COLBEA ENTERPRISES, LLC SITE PLAN

SP# 09-23

STAFF REPORT

September 11, 2024

PSW01

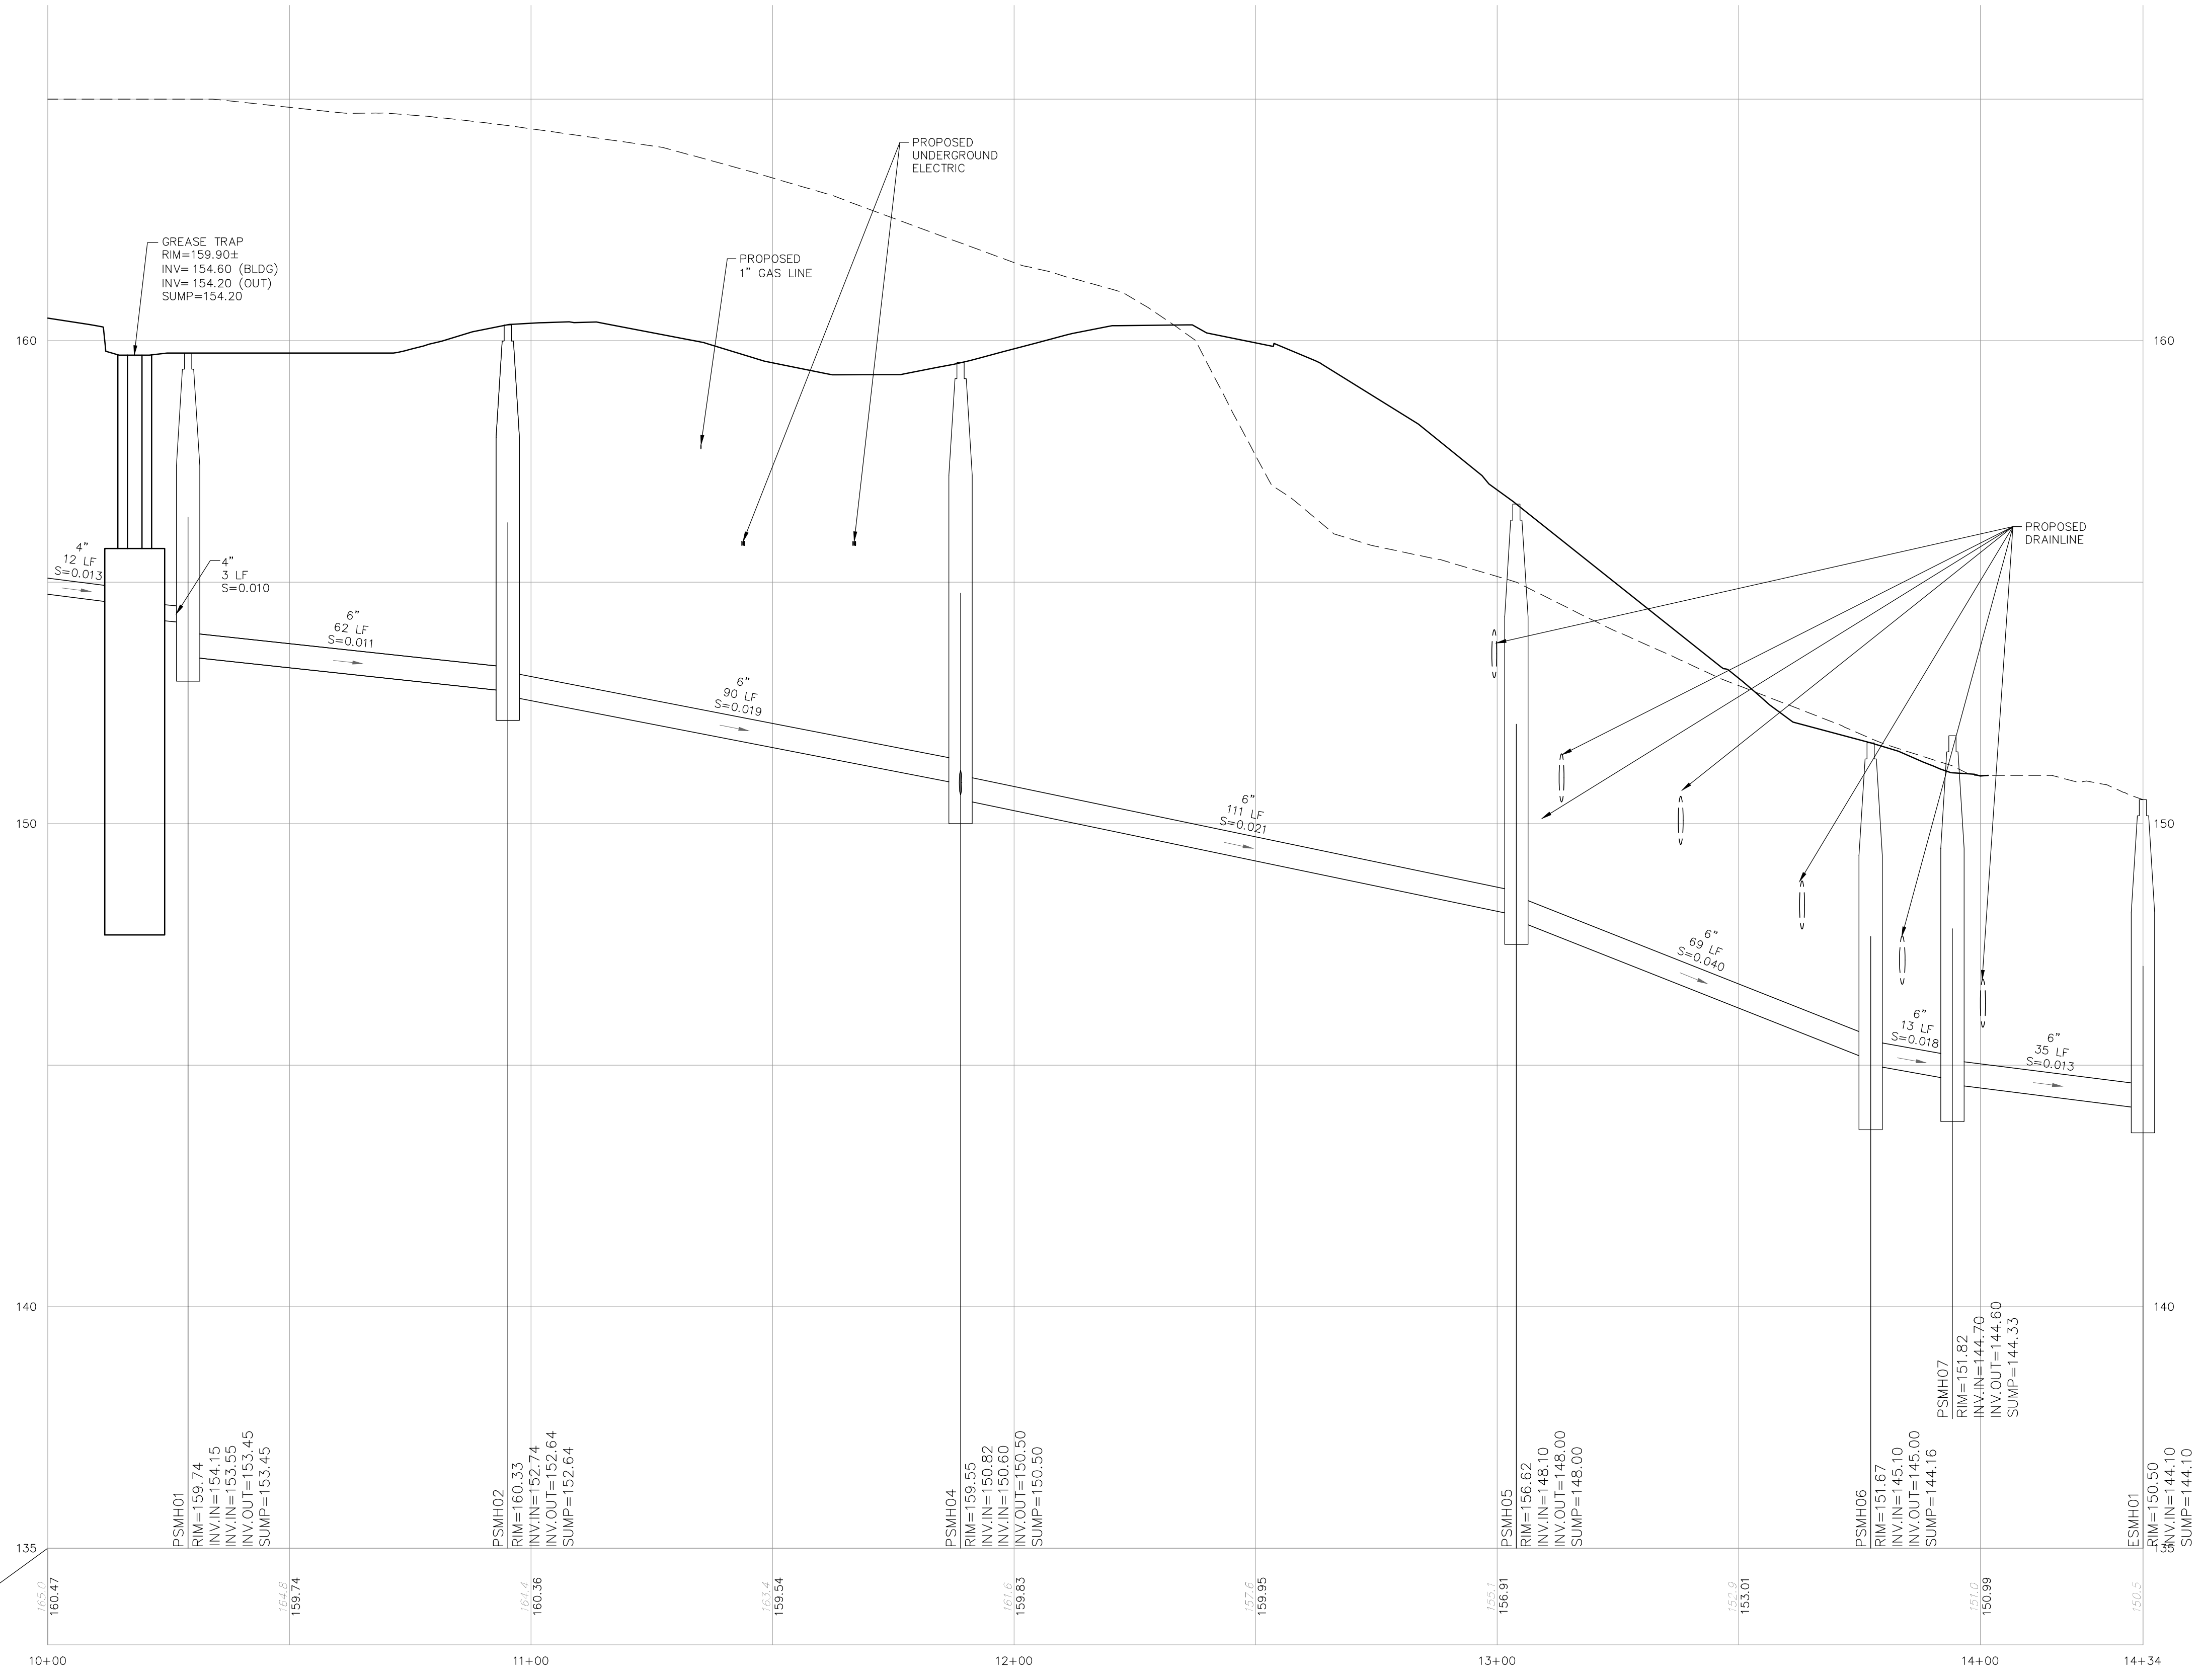
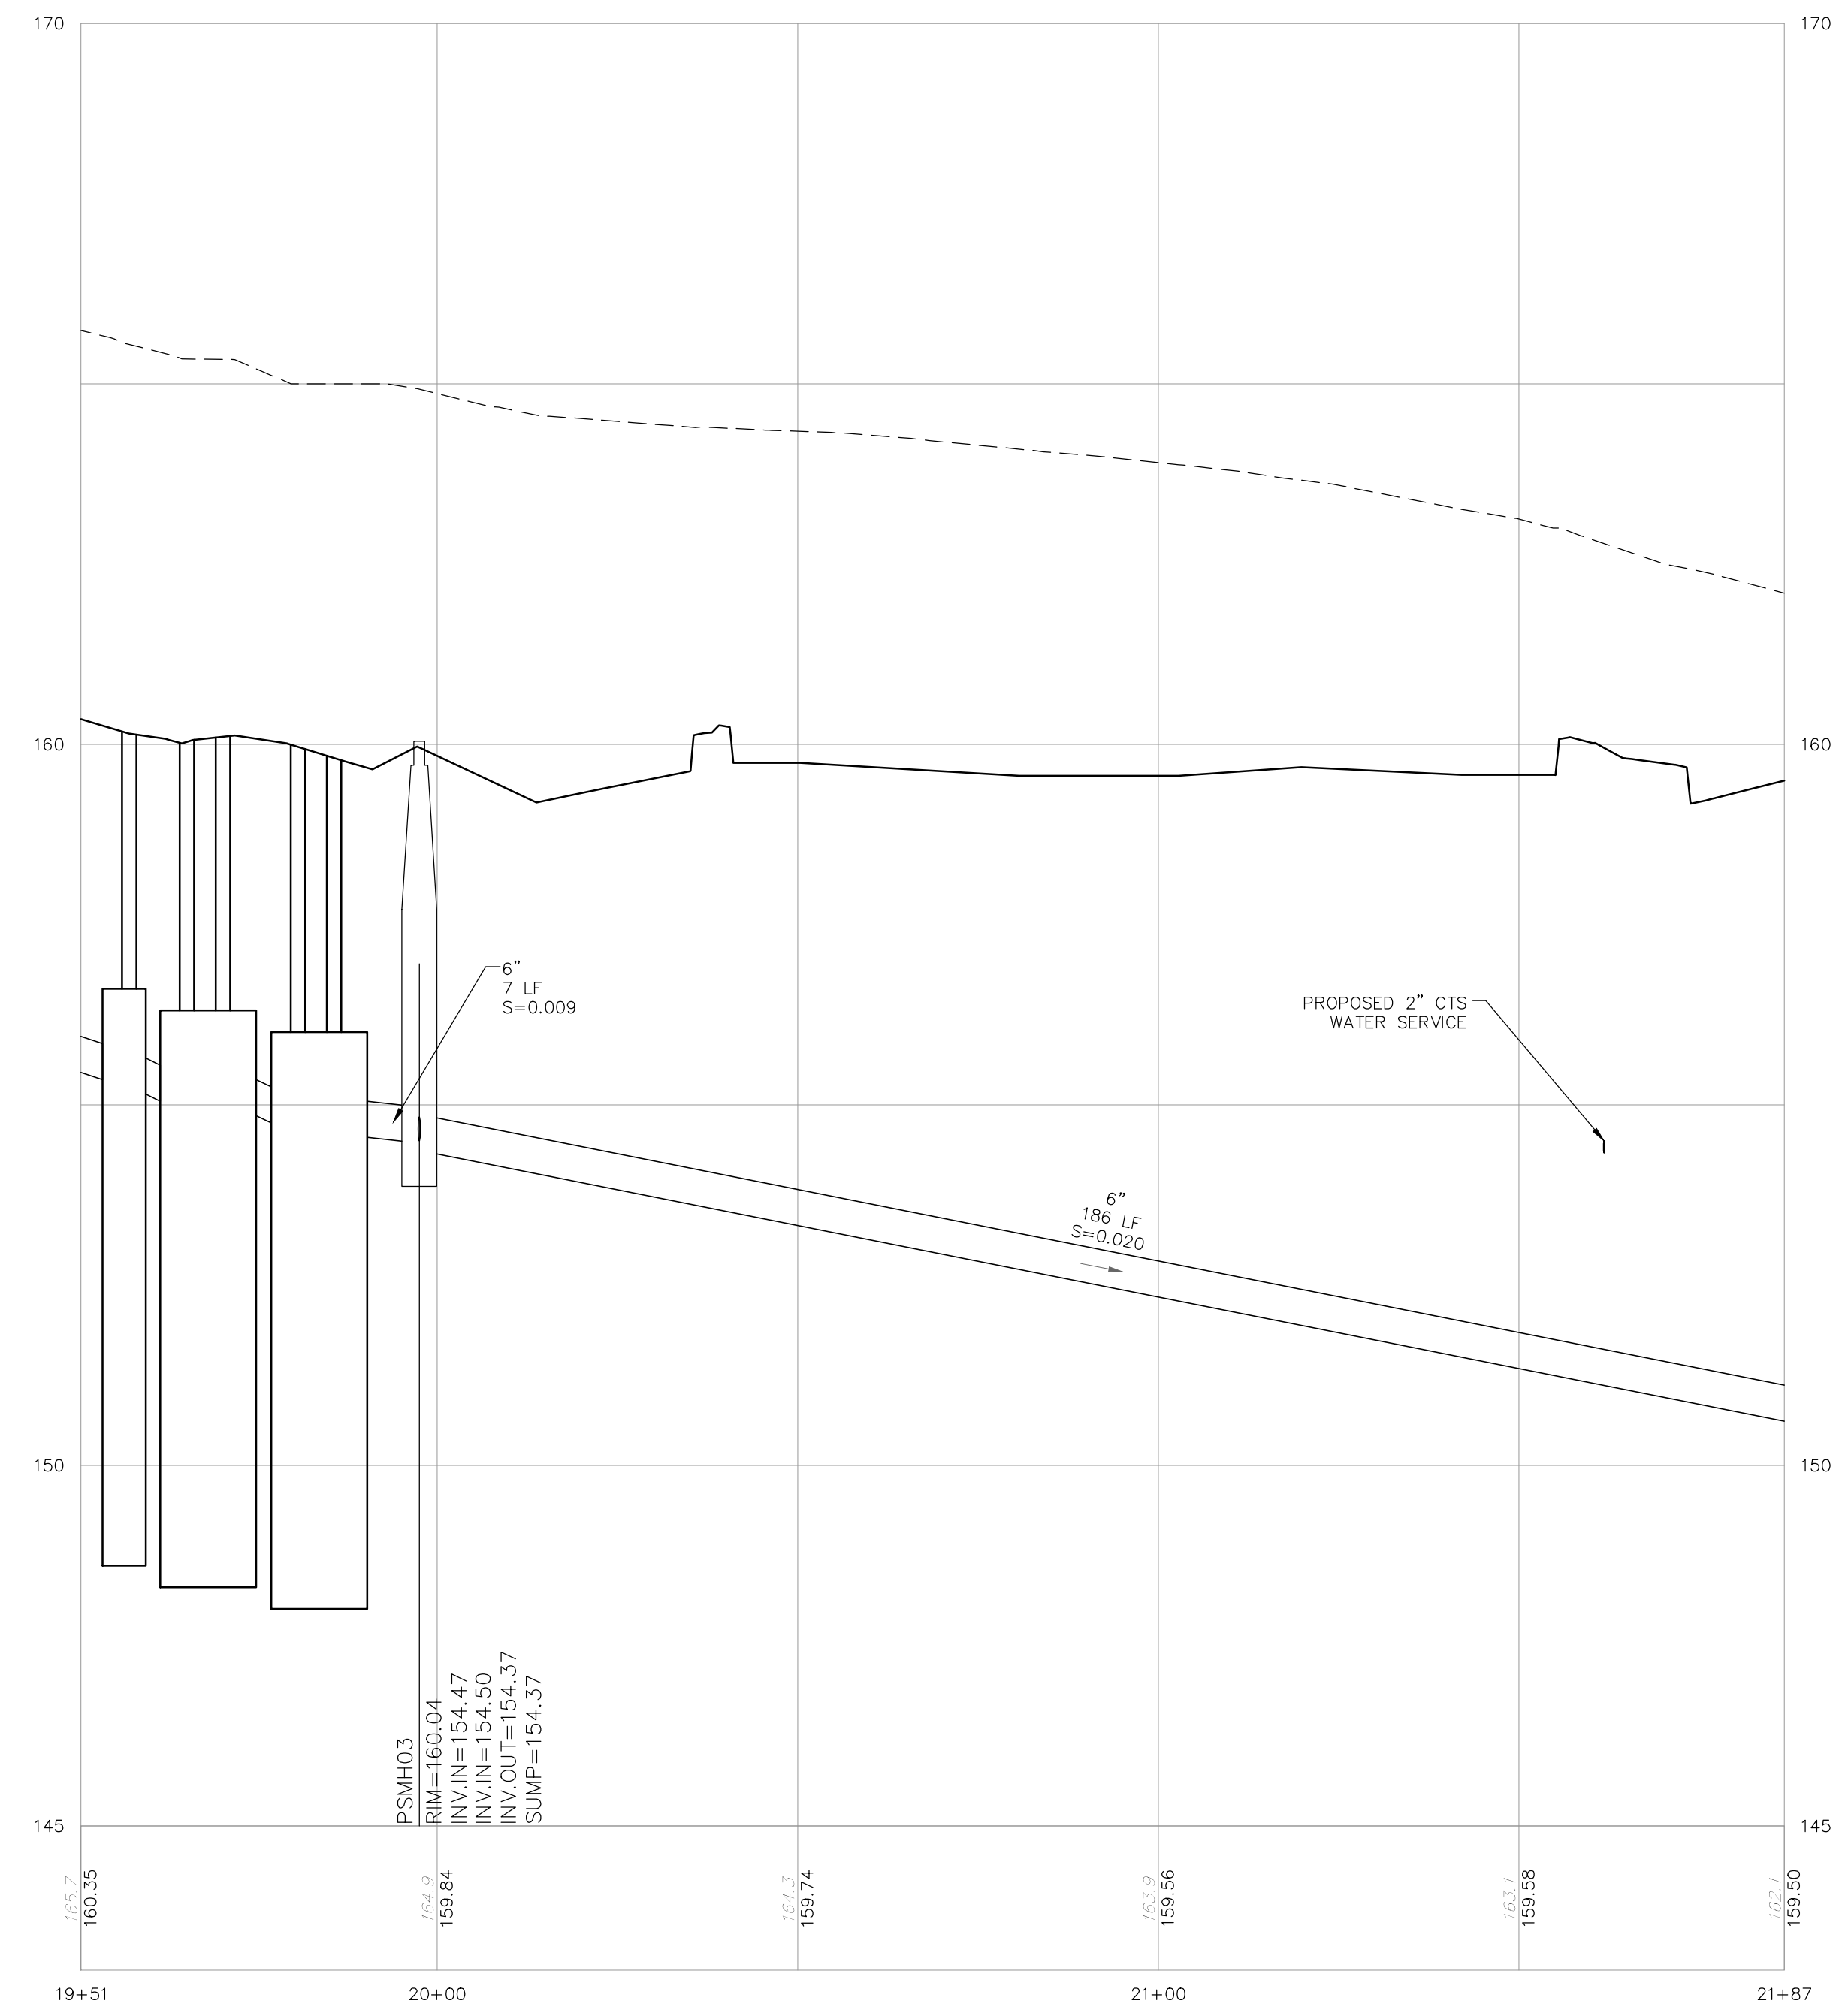
- i. HR 275-9.E & 276-13. The applicant has labelled SMH-04 on two separate manholes on plan sheet C-08. One of these should be SMH-05.
- j. HR 275-9.E & 276-13. There are several drainage crossings of the sewer pipe between SMH-03 and SMH-04. This run of sewer pipe is not shown on a sewer profile. The applicant should confirm that there are no conflicts between drainage and sewer in this area and that there is adequate separation between these utilities.

- i. ***Noted. Sufficient water flow will be coordinated with the Town.***
- i. HR 275-.9.E & 276-13. The applicant has labelled SMH-04 on two separate manholes on plan sheet C-08. One of these should be SMH-05.

- i. *Former Fuss & O'Neill Comment: HR 275-.9.E & 276-13. The applicant has labelled SMH-04 on two separate manholes on plan sheet C-08. One of these should be SMH-05.*
Current Fuss & O'Neill Comment: The applicant has revised the labeling. No further Fuss & O'Neill comment.
